Access Compliance Report Public Rights-of-Way (Curb Ramps)

Main Street: SIENNA_PKWY Cross Street: FLINTRIDGE_AVE Location: W

ADA ID: RPRK211108123342 Ramp Type: Type 4 - Parallel Initial Pass/Fail: Fail Overall Compliance: No Severity Score: 16

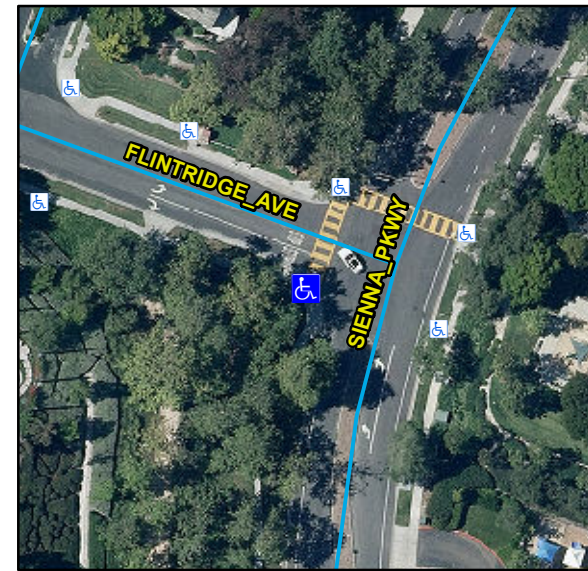
Compliance	Description	Data	Compliance	Description	Data
N/A	Ramp Length LT (in)	107	N/A	Ramp Length RT (in)	107
Yes	Ramp Width LT (in)	96	Yes	Ramp Width RT (in)	96
Yes	Ramp Run Slope LT (%)	4.3	No	Ramp Run Slope RT (%)	10.3
No	Ramp Cross Slope LT (%)	3.4	Yes	Ramp Cross Slope RT (%)	1.7
N/A	Landing Present	N/A	N/A	DWS Provided	N/A
N/A	Landing Length (in)	N/A	N/A	DWS Contrast	N/A
N/A	Landing Width (in)	N/A	N/A	DWS Length (in)	N/A
N/A	Landing Run Slope (%)	N/A	N/A	DWS Full Width	N/A
N/A	Landing Cross Slope (%)	N/A		DWS Offset Type	N/A
N/A	Landing Movement Obstructed?	N/A	N/A	DWS Offset Left (in)	N/A
	Landing Movement Type	N/A	N/A	DWS Offset Right (in)	N/A
N/A	Landing Shared	N/A			
N/A	Clear Space	Yes			
N/A	Clear Space To Crosswalk (in)	N/A			
N/A	Marked Crosswalk 1	No	N/A	Marked Crosswalk 2	Yes
	Crossing 1 Direction	SE		Crossing 2 Direction	NE
	Marked Crosswalk 1 Width (in)	N/A		Marked Crosswalk 2 Width (in)	144

Remove & Replace Curb Ramp With Two New Directional Ramps or Equivalent. Restripe Crosswalk.
